CITY OF SAN MARCOS

CONSTRUCTION CHANGE ORDER

PROJECT: Police Department Additions & Renovations
CONTRACT NO.: 220-149

Date Prepared: 08.06.2021
Change Order #: 12

Boiler Room Conflict

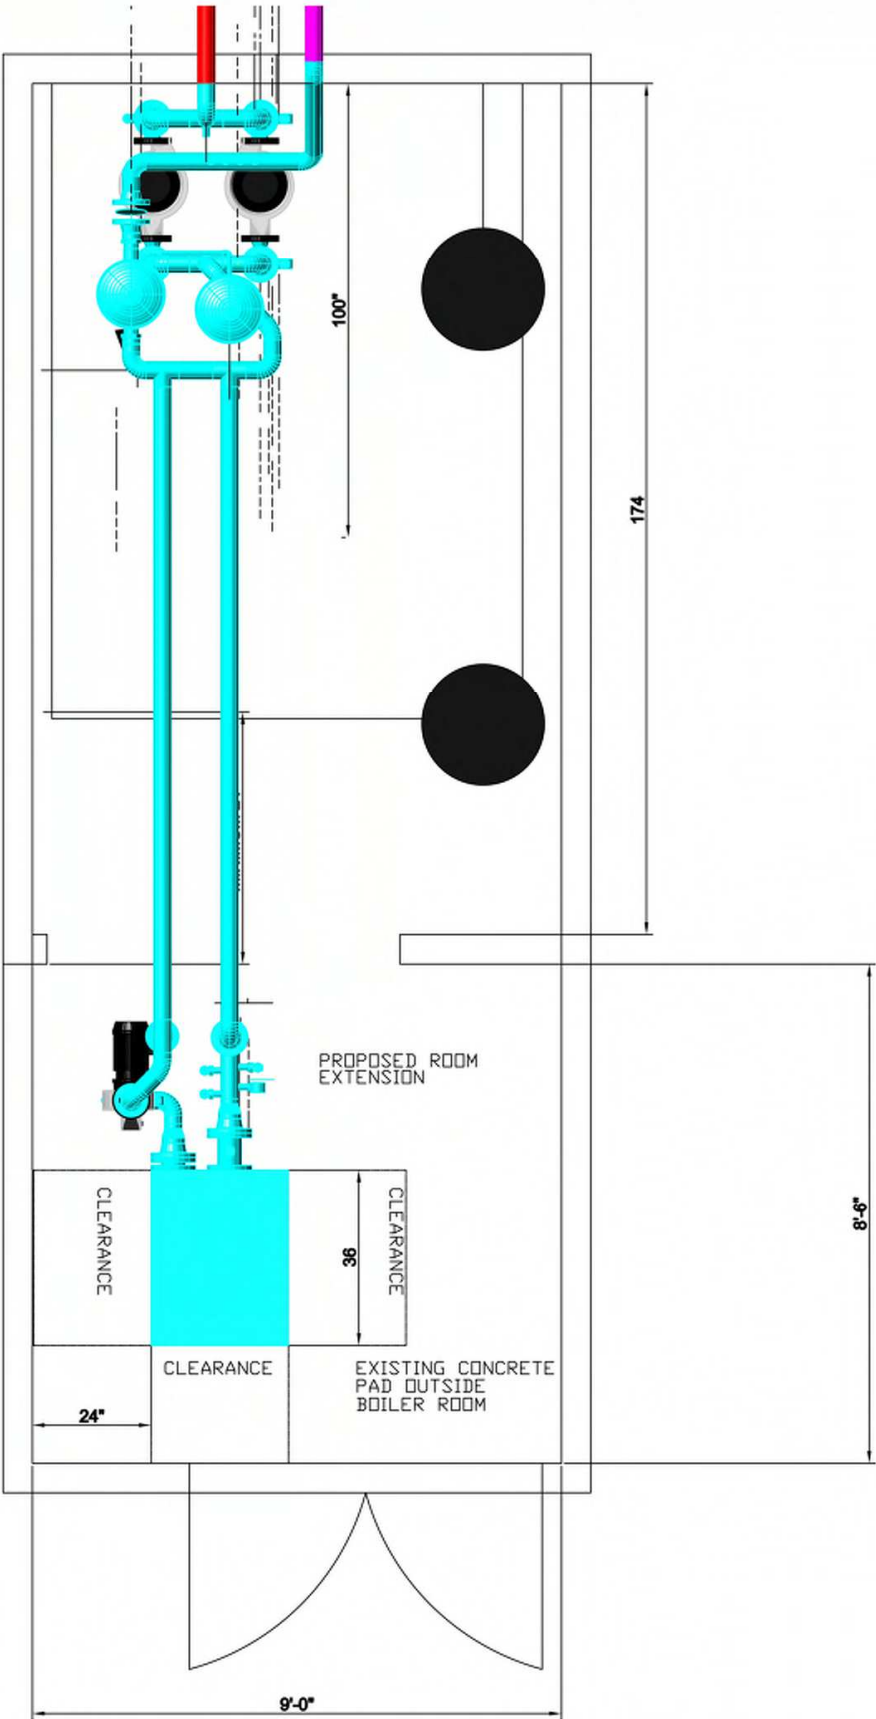
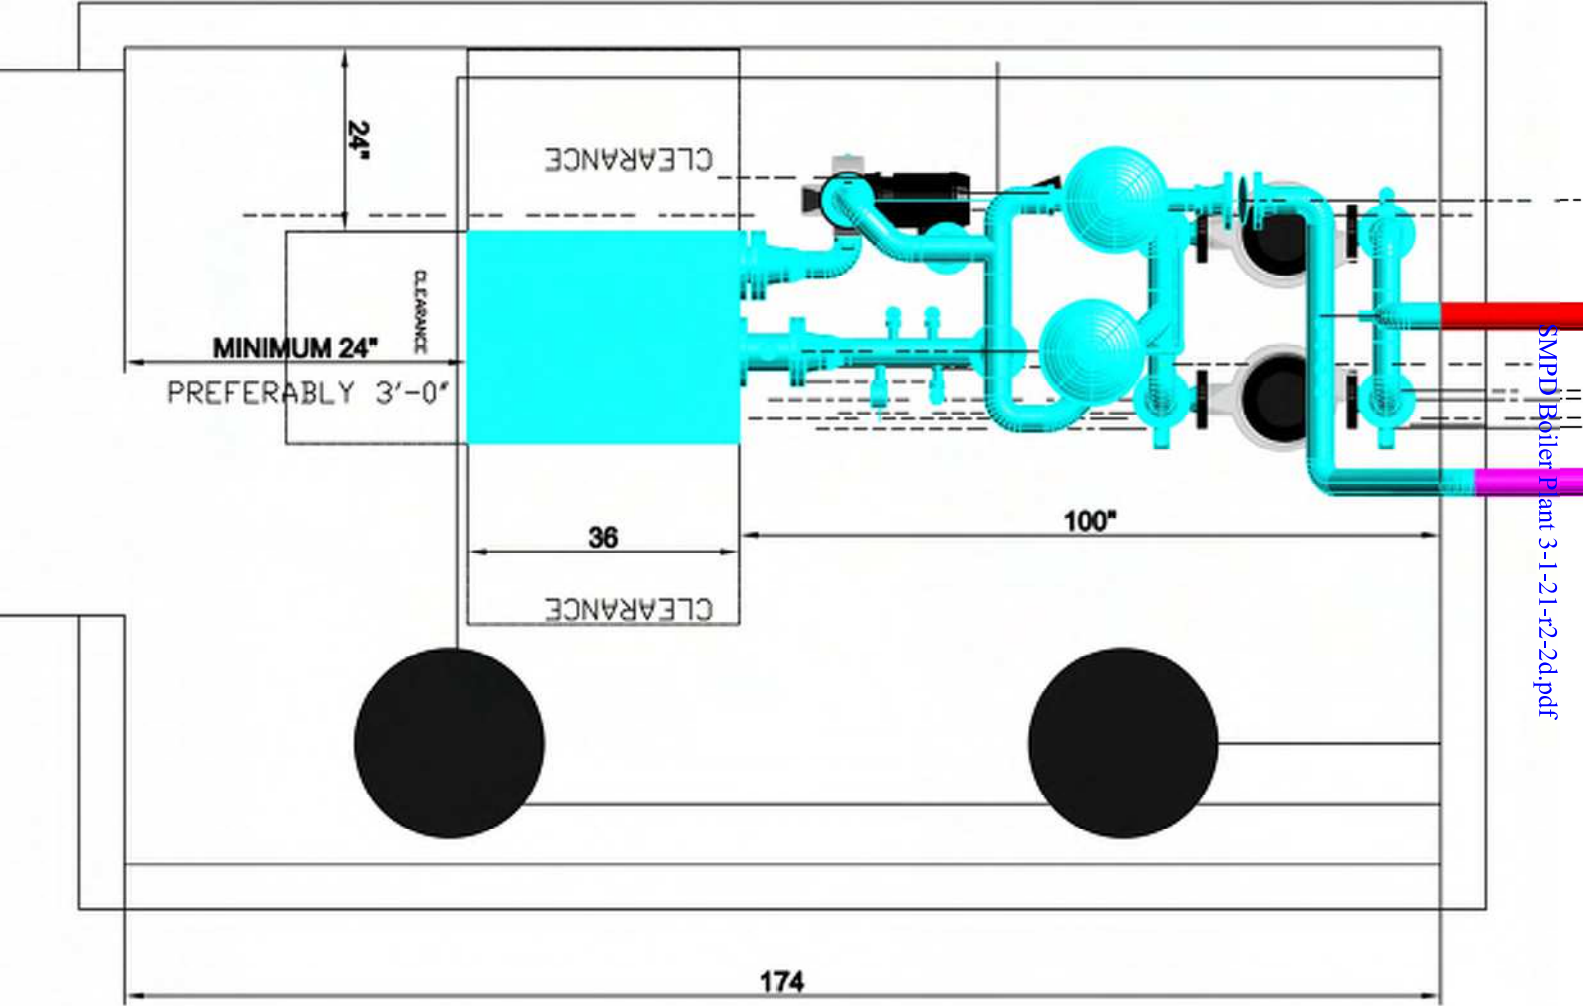
Kristy, Late yesterday Trimbuilts mechanical contractor sent his in house drawings which shows R2= revision #2 which is what we have now and R3 option to extend the boiler room towards the parking lot.

As mentioned below, There is a 2d and 3d file for each revision.

Per site conversation on 3-11-2021, a room extension will not be needed. Please add a door connecting the boiler room to the hallway at the northeast corner of the room. The door shall be a 3'0 x 7'0 type K door (with fixed transom panel). The hardware for this door shall be a basic storeroom lock set similar to what is provided for door 311.
